STAFF REPORT

TO: Planning Commission
FROM: Ken Roberts, Planning Director
AGENDA ITEM: **Schiltgen Farms PUD Concept Plan and Comprehensive Plan Amendment**
REVIEWED BY: Ken Roberts, Planning Director
Ben Prchal, City Planner
Jack Griffin, City Engineer
Ann Pung-Terwedo, Senior Planner, Washington County

Mr. Ben Schmidt, representing the Excelsior Group, is requesting approval of a concept planned unit development (PUD) for the Schiltgen Farm property located 10880 Stillwater Boulevard. Concept PUD review requires a public hearing.

CONCEPT PLAN

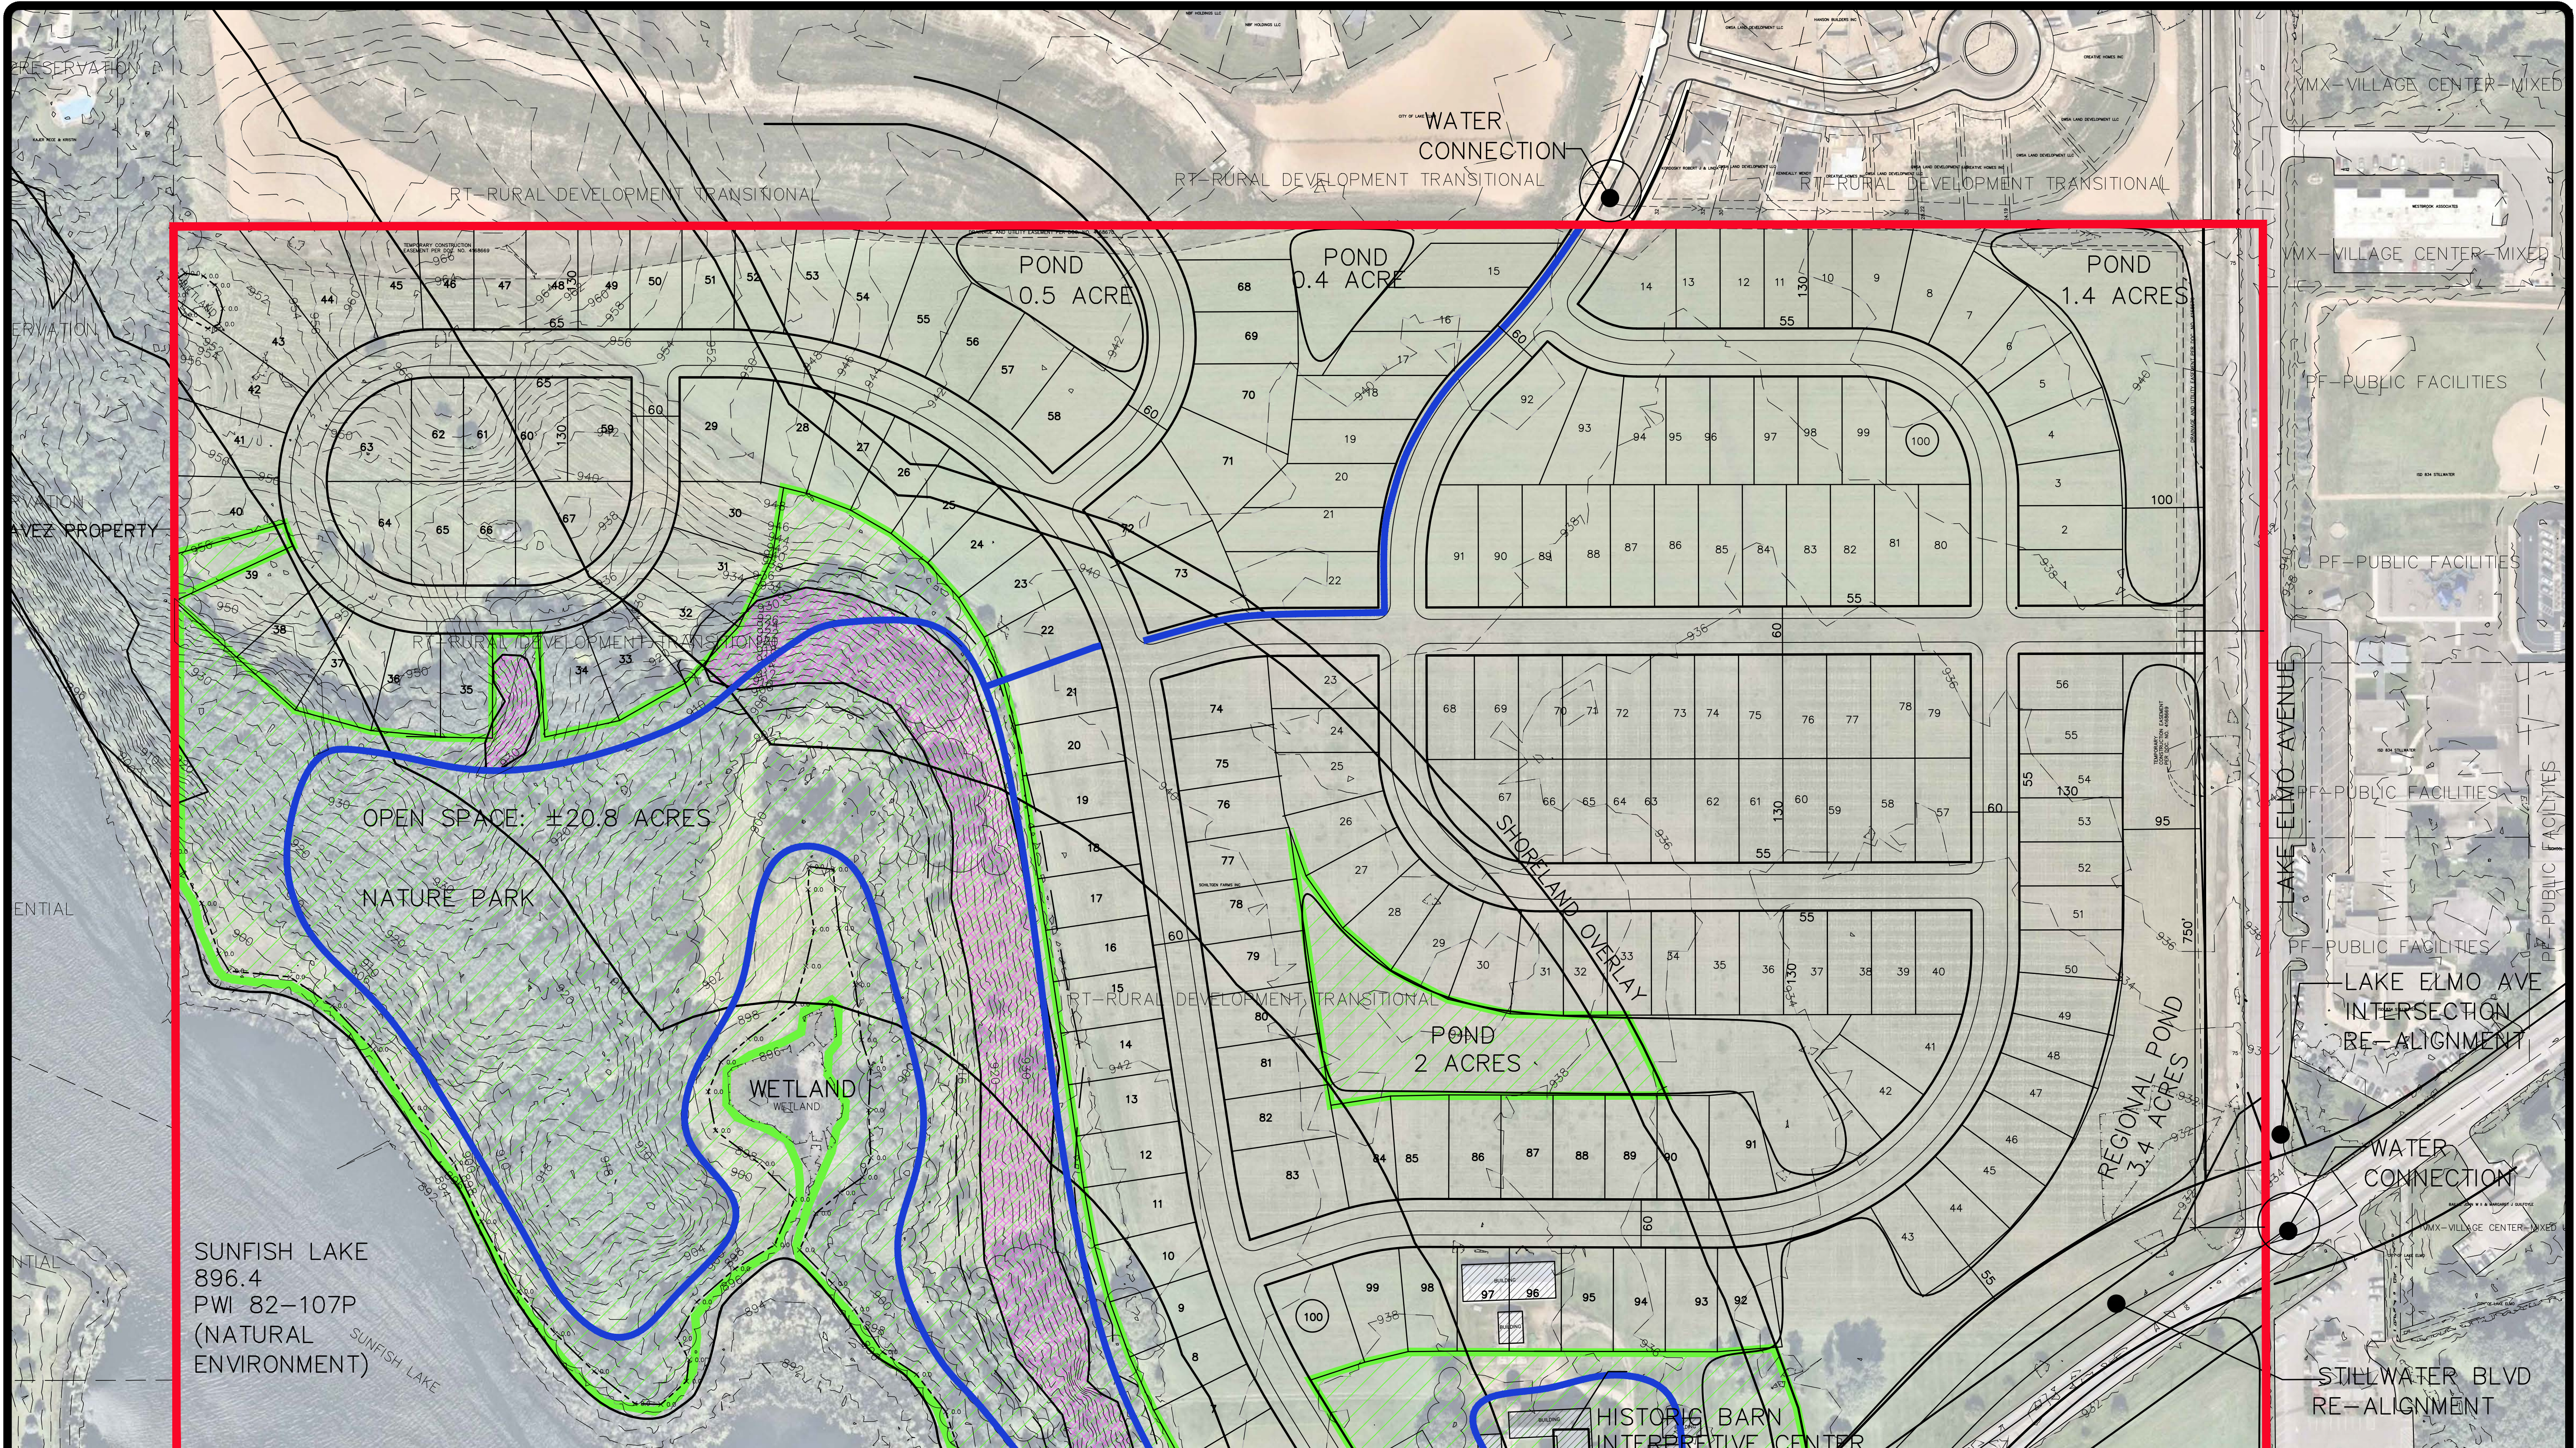
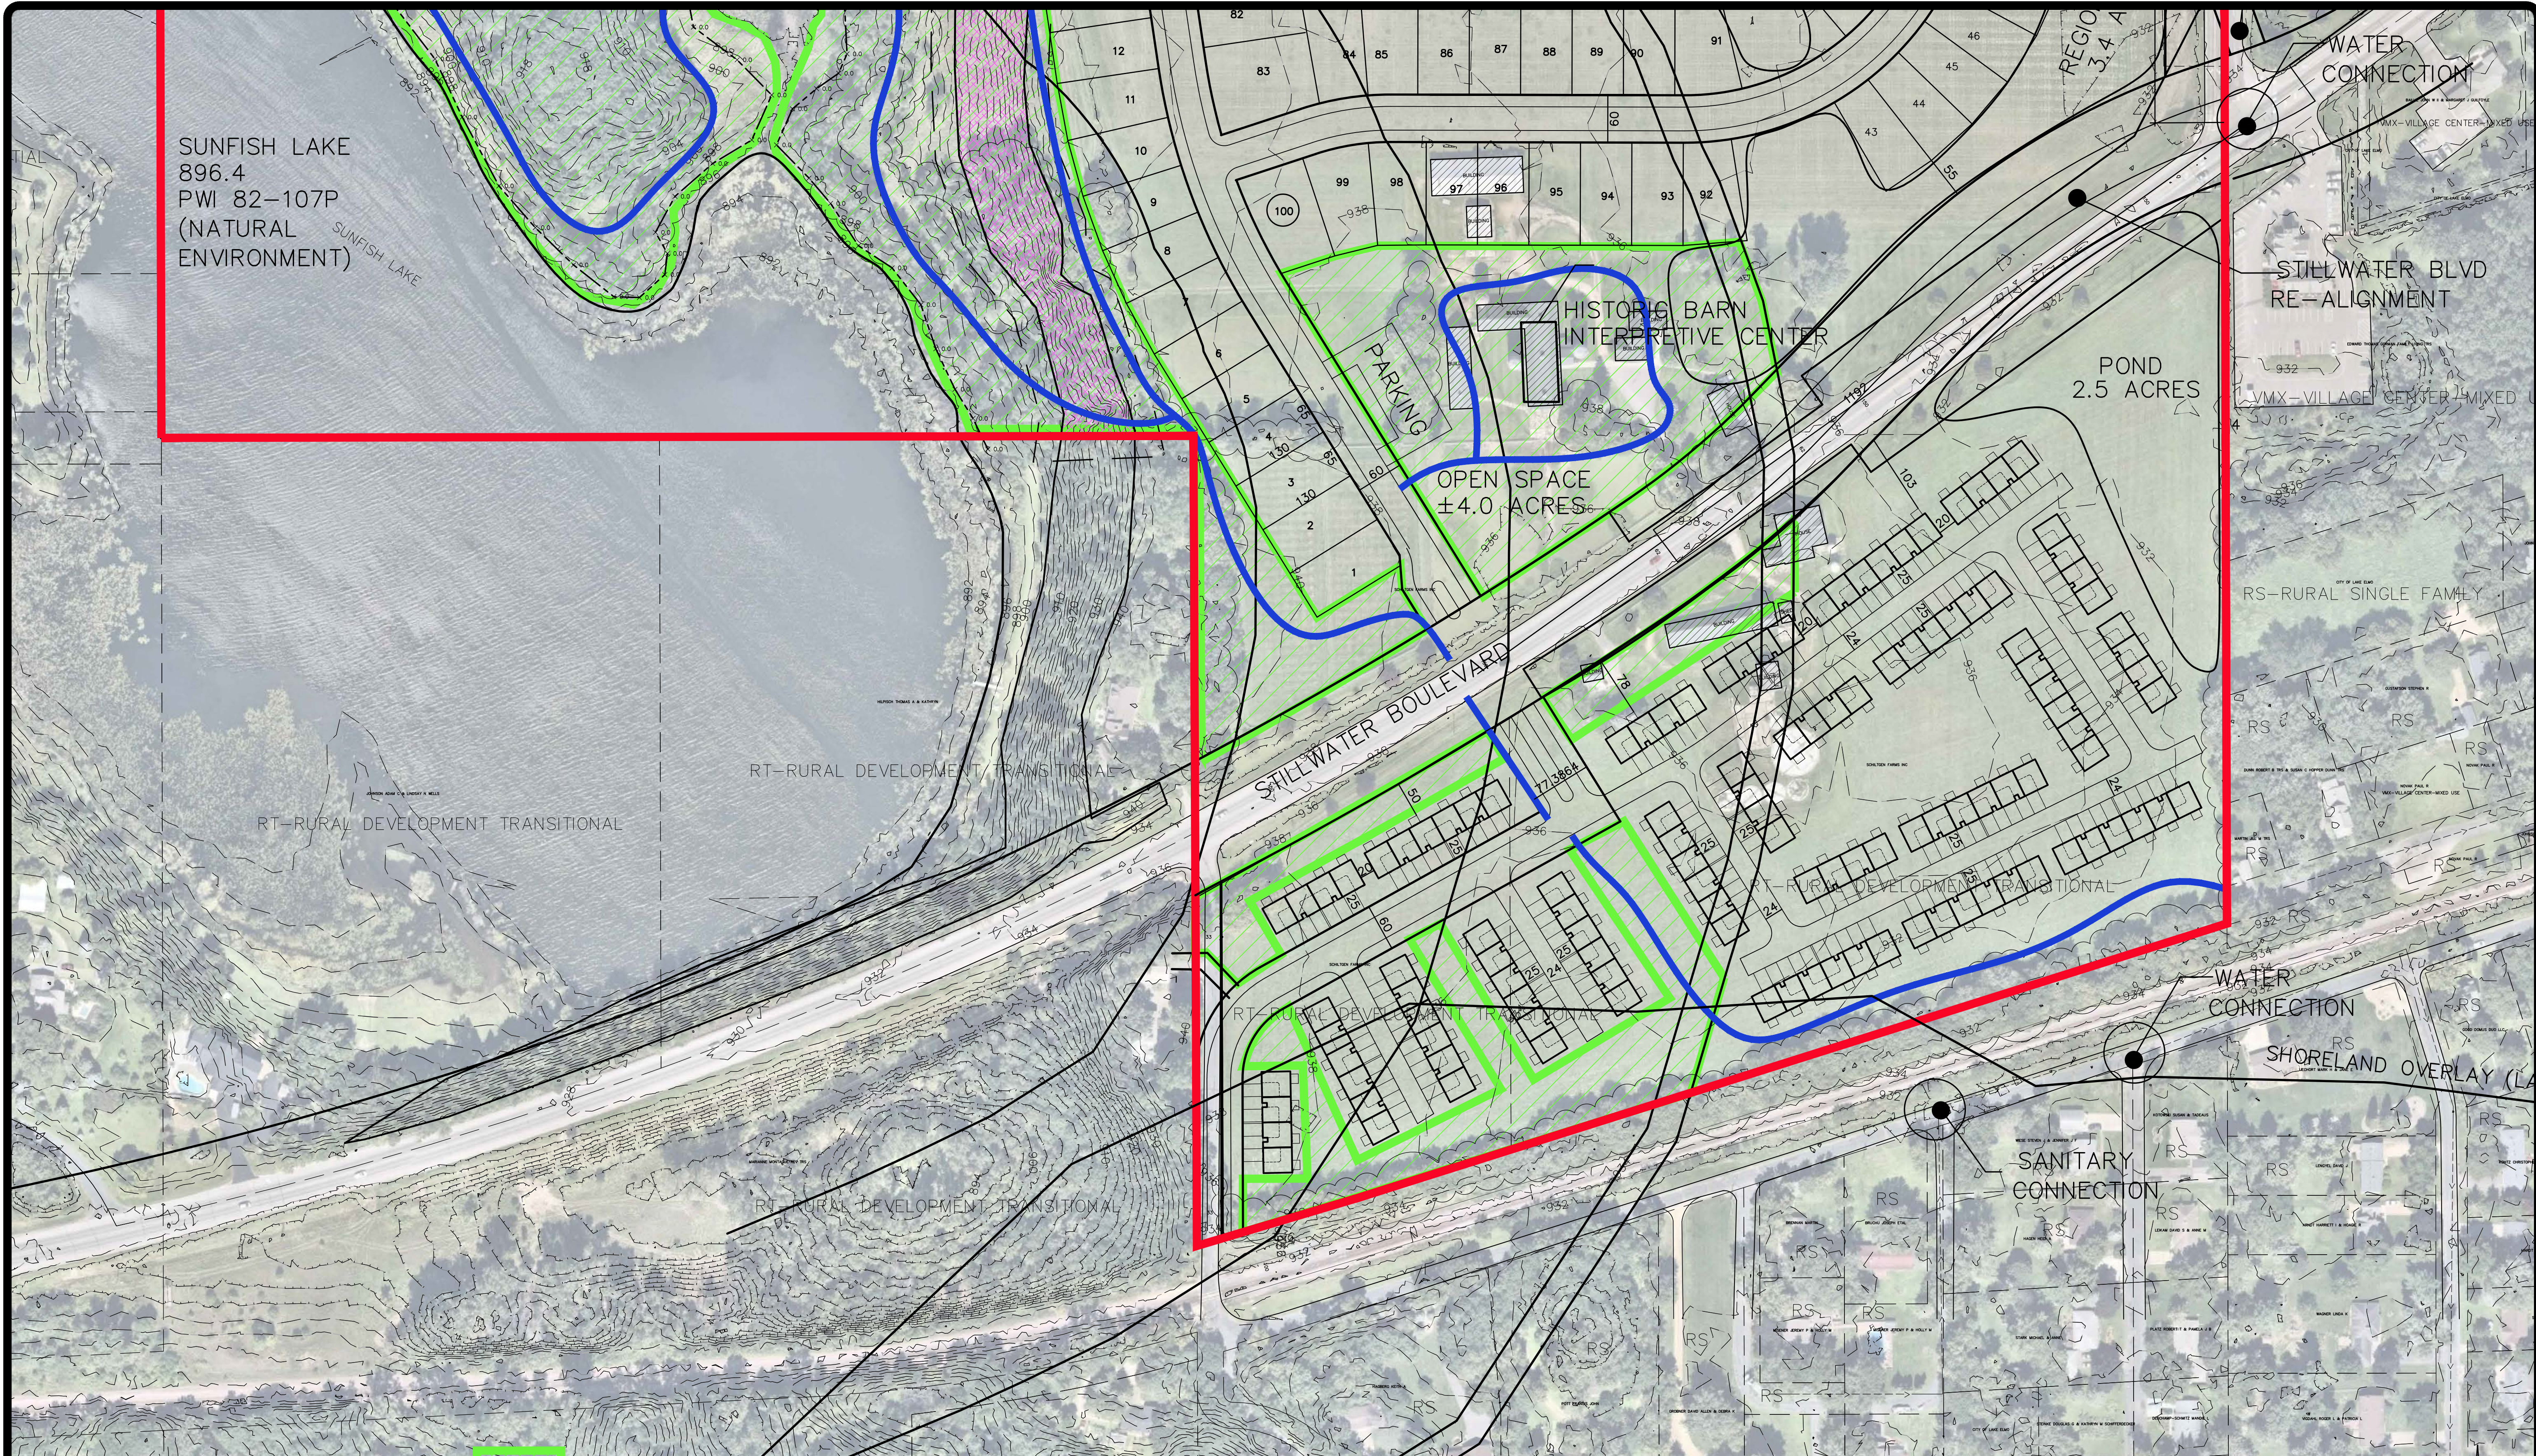
- c. Street Layout: The PUD ordinance appears to place a preference for a street grid to compliment the older portions of the City. The proposed PUD development incorporates a modified street grid and shows connections to the new streets that were recently constructed to the north of his site in the Legacy of North Star development.

Sidewalks. The City's standard street detail requires a 6 foot wide public sidewalk be constructed on one side of any public street and to accommodate a sidewalk, the standard right-of-way width is 60 feet wide. The proposed concept plan shows 60-foot-right-of-ways for the public streets within the development but they do not show sidewalks on any streets.

The Concept Plan shows a trail extending into the development from the Legacy at North Star development that would proceed south and west to the open space area adjacent to Sunfish Lake. The plans also shows a trail around much of the open space area, behind several of the homes, in and around the barn and crossing Stillwater Boulevard to proceed south and east near the railroad tracks.

Having an off-street trail in this area will allow for easy pedestrian connectivity between these parts of the developments and to the future play area to the north. It appears that a possible location for such a trail would be between Lots 43 and 44. The City should require the developer to study the options for public trail connections in this area as they prepare the preliminary plat and PUD plans. I have attached 3 maps showing this area in more detail for your reference.

5. Revising the access point along County Road 14 as it is less than the county's ¼ mile access guideline from County Road 17. The County suggests the developer use Klondike Avenue as their access point as it is just over ¼ mile from the intersection with County Road 17. This issue will require further analysis as the existing location of Klondike Avenue could not provide access to the north side of Stillwater Boulevard as it is west of the west property line of the project site.

7. The Concept Plans do not reflect the regional pond as planned during the Downtown Lake Elmo/CSAH 17/Lake Elmo Avenue improvement project. Staff note: The project plans show locations for possible ponding area on the site.

Streets. The developer is proposing a modified street grid and is proposing 60 foot wide public rights-of-ways with 28' wide streets (back to back), allowing parking on both sides of the street, except where center island exist, such as at the entrance roads off of Lake Elmo Avenue and Stillwater Boulevard. For the area south of Stillwater Boulevard, the developer's plans show rerouting Klondike Avenue to the east into the development site so it would create an intersection on Stillwater Boulevard with the new street that would be north of Stillwater Boulevard. The County, as noted above, has flagged the proposed intersection location as being too close to the intersection with County Road 17. The remainder of the streets south of Stillwater Boulevard would be private driveways that would provide access to the proposed townhouses.

There may be an opportunity and a need for the developer to provide a public street access to the adjacent property to the east, just south of the 2.5 acre ponding area. This connection would be to property at the west end of 34th Street and would allow for 34th Street to eventually continue west. If not a street connection, there may be a need for trail and/or an utility easement in southeast corner of the development to allow for public pedestrian access between properties and for utilities to connect between the existing neighborhood and the new neighborhood. The City should require the developer to study this in more detail as they prepare the preliminary plat and PUD plans.

Stormwater Management. No stormwater management plan has been prepared for the project at this time. The proposed concept plan shows six areas for storm water ponding totaling about 10.2 acres in area. The City Engineer's memorandum addresses general stormwater management considerations that the City will require as part of this development. He will need to see additional details before commenting in any detail on any proposed storm water management plan, and in particular, how the storm water ponds or basins would be connected and how the storm water system would allow emergency overflow from the ponds. He also noted there should be a system of interconnecting drainage ways incorporated into the design.

8. That the future preliminary plat and preliminary PUD Plans submittal show possible trail connections near Lots 43 and 44 in the northwest corner of the Concept Plan to the City-owned property around the storm water ponding area to the north or to the existing trails in the Hamlet of Sunfish Lake neighborhood to the northwest of the site. The City will require the developer to plat such a trail on its own parcel.

9. That the future preliminary plat and preliminary PUD Plans submittal show possible trail connections to the area east of the southern part of development site near Upper 33rd Street or 34th Street and south of the proposed storm water ponding area. The City will require the developer to plat any such trails on its own parcel.
